HVAC Flange, Installation
VN, VHD, VAH

FSB 873-020, HVAC Flange, Installation

(May 2016)

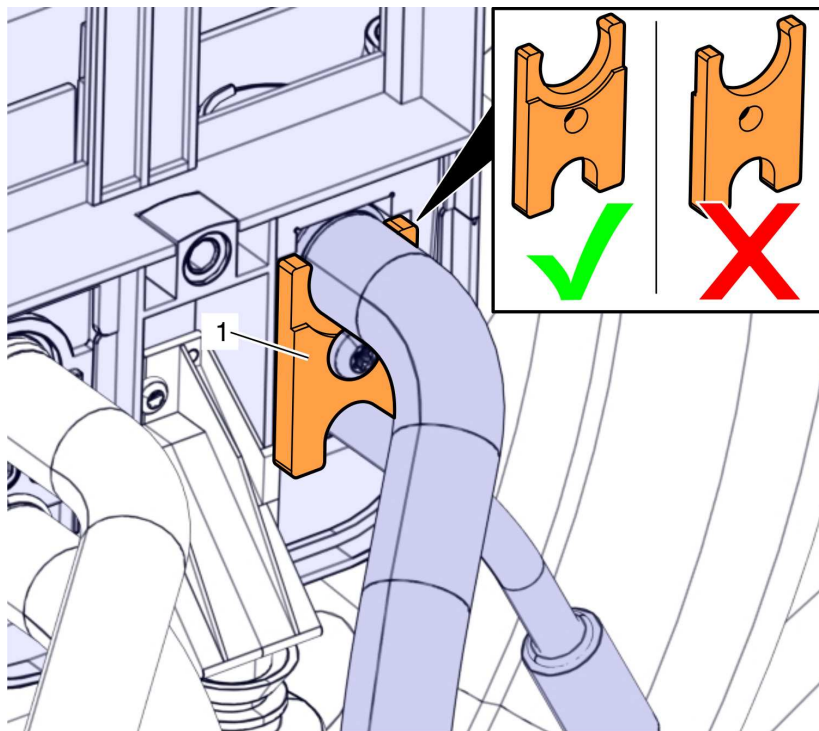
The new flange bracket used to secure the AC lines to the HVAC units (front & bunk) may be installed incorrectly starting in production week1614. Follow the reference image in this Field Service Bulletin (FSB) to ensure proper installation of the HVAC flange bracket.

Note: The HVAC flange bracket should be installed with the machined Surface (1) facing away from the main and bunk climate unit as shown in the reference image.
